Access Compliance Report

Public Rights-of-Way (Curb Ramps)

Intersection ID: 15205	Main Street: CHEROKEE_RD	Cross Street: FENTON_PL	Location: NW
ADA ID: 1FADB539A8C2	Ramp Type: Directional1	Initial Pass/Fail: Fail	Overall Compliance: No
		Severity Score: 10

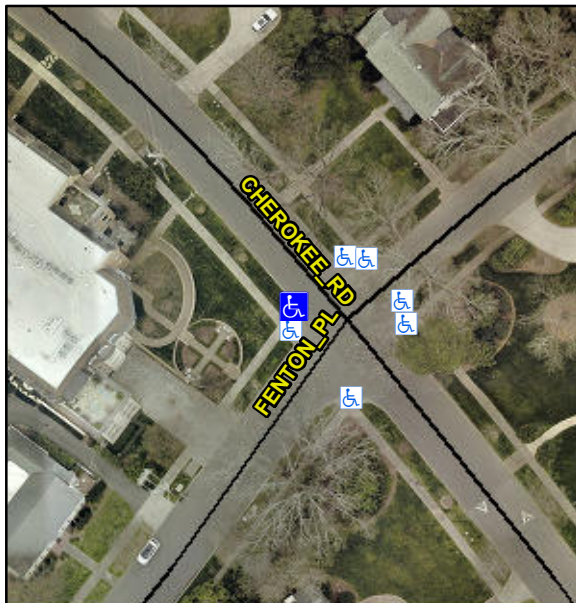
R304.5.1, R304.5.3

Compliance	Description	Data	Compliance	Description	Data
N/A	Ramp Length (in)	113.0	N/A	Grade Break?	N/A
No	Ramp Width (in)	45.0	N/A	Grade Break Slope (%)	0.0
Yes	Ramp Slope (%)	7.0	N/A	Grade Break XSlope (%)	0.0
No	Ramp XSlope (%)	4.1			
N/A	Flare Type LT	N/A	N/A	Flare Type RT	N/A
N/A	Flare Slope LT (%)	N/A	N/A	Flare Slope RT (%)	0.0
N/A	Flare Traversable LT?	N/A	N/A	Flare Traversable RT?	N/A
N/A	Landing Length (in)	0.0	N/A	DWS Provided?	N/A
N/A	Landing Width (in)	0.0	N/A	DWS Contrast?	N/A
N/A	Landing Slope (%)	0.0	N/A	DWS Length (in)	N/A
N/A	Landing X Slope (%)	0.0	N/A	DWS Full Width?	N/A
N/A	Landing Curb? (Y/N)	N/A	N/A	DWS Offset LT (in)	N/A
N/A	Shared Landing?	N/A	N/A	DWS Offset RT (in)	N/A
N/A	Gutter Ponding?	0.0	N/A	Gutter Slope (%)	N/A
N/A	Gutter Lip Ht (in)	0.0	N/A	Gutter X Slope (%)	N/A
N/A	Painted X Walk1?	No		Road Slope (%)	5.8
	X Walk 1 Direction	To NE		Road X Slope (%)	0.5
	X Walk 1 Width (in)	N/A		Clear Space?	N/A

X Walk 1 Slope (%)	5.8	N/A	Clear Space to XWalk (in)	N/A
	X Walk 1 X Slope (%)	0.5	N/A	Storm Grate/Utility Hazard?	N/A
N/A	Ramp inside XWalk1?	N/A		Storm Grate/Utility Type	
N/A	Any Obstructions?	N/A			N/A
	Obstruction Type		Yes	Surface Condition? (G/P)	Good
			N/A	Curb Slope (%)	9.4

Remove & Replace Entire Ramp.
